UNITED STATES PATENT AND TRADEMARK OFFICE

APPLICATION NO.	FILING DATE	FIRST NAMED INVENTOR	ATTORNEY DOCKET NO.	CONFIRMATION NO.
10/785,008	02/25/2004	Ho Gyeong Yun	123034-05004911	9730
43569	7590	08/31/2005	EXAMINER	
MAYER, BROWN, ROWE & MAW LLP 1909 K STREET, N.W. WASHINGTON, DC 20006			PENG, CHARLIE YU	
			ART UNIT	PAPER NUMBER
			2883

Office Action Summary	Application No.	Applicant(s)	
	10/785,008	YUN ET AL.	
	Examiner	Art Unit	
	Charlie Peng	2883

DETAILED ACTION

FIG. 1 (a)

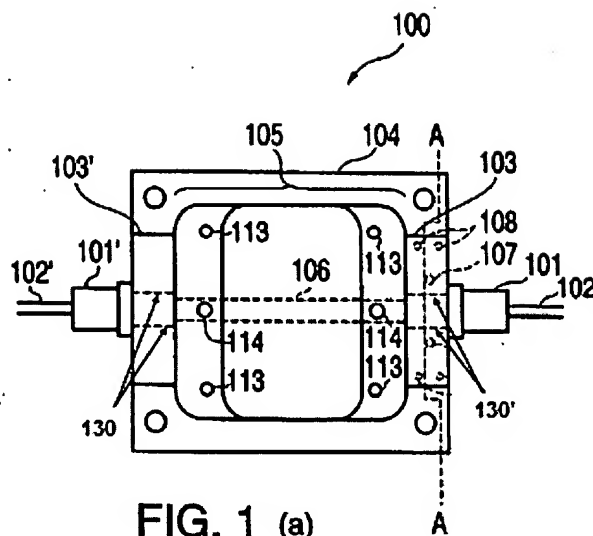
Claims 1-16 are rejected under 35 U.S.C. 103(a) as being unpatentable over U.S. PGPub 2002/0146227 to Suzuki et al. Suzuki et al. teaches an optical collimator module **100** that has a base member **104** (i.e., a bottom surface) with two holding members **103, 103'** (i.e., two outer walls), the two holding members **103, 103'** each has a hole (as indicated by the dashed lines **130, 130'** on included drawing Fig. 1(a) having additional labels by the examiner) with optical collimators **101, 101'** and optical cables **102, 102'** inserted therein, and wherein the three members form a U-shape. (See at least Fig. 1 and its description.) Although Suzuki et al. do not specifically place an optical device on the bottom surface, combining such a part is obvious and also disclosed in review of prior art by Suzuki et al., wherein an optical functional component **205**, in a similar U-shaped optical collimator module, is placed in a beam path **106** between two collimators/fiber cables. It would therefore have been obvious to one of ordinary skill in the art at the time the invention was made to place a functional optical component in the optical module by Suzuki et al. The motivation would be to enable optical functions such as switching (via a filter, a mirror, etc.), optical signal receiving (via a photodiode), or optical signal transmitting (via a laser, an LED, etc.)

With specific references to claims 2, 4, 6, 8, 10, 12, 14, and 16, it is immediately obvious from at least Fig. 1(a) and its description in Suzuki et al. that the two outer walls 103, 103' are of different due to the fact that the outer wall 103 are shortened so screws 107, 108 can be placed between the outer wall 103 and the bottom surface.

FIG. 4 (a)

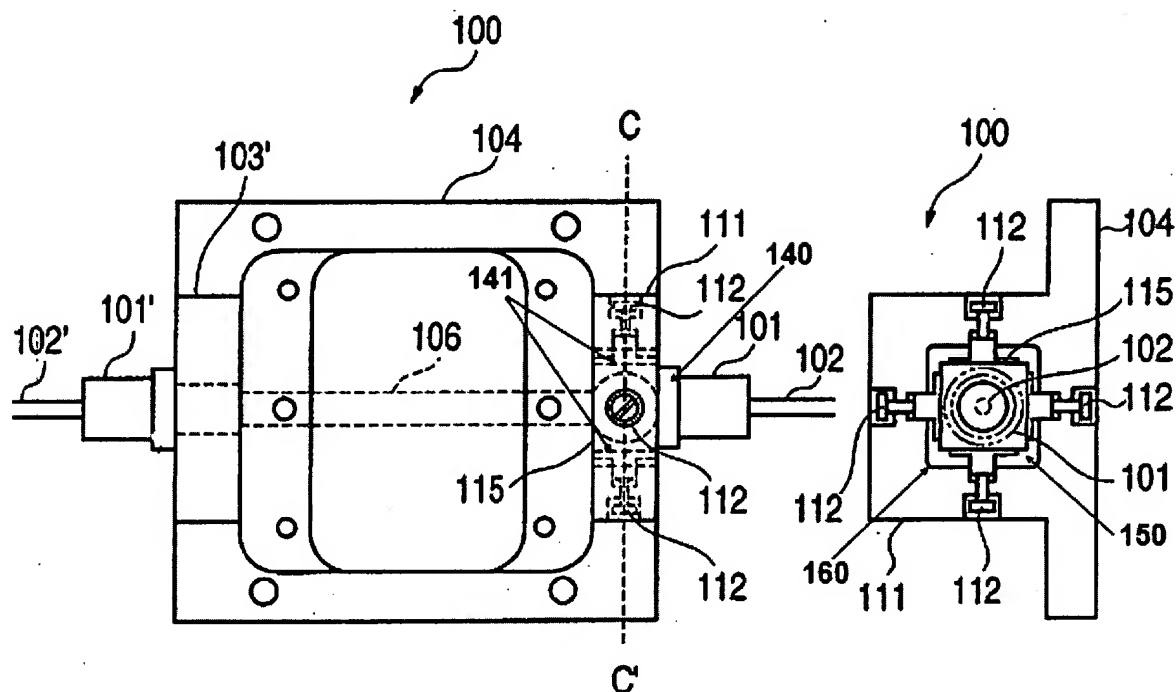
With specific reference to claims 9 and 11, Suzuki et al. teach a ring 140 encircling the first collimator 101. The ring is also outlined by dashed lines 141 and placed within a hole 160 of an outer wall 111 of the base member 104. The hole 160 is substantially different in shape (square) and size from a second hole, in which the second collimator 101' is inserted. (See at least included drawing Figs. 4(a) and 4(b) having additional labels by the examiner and description.) A space 150 exists inside the hole 160, wherein alignment of the collimator 101 can be made by adjusting screws 112.
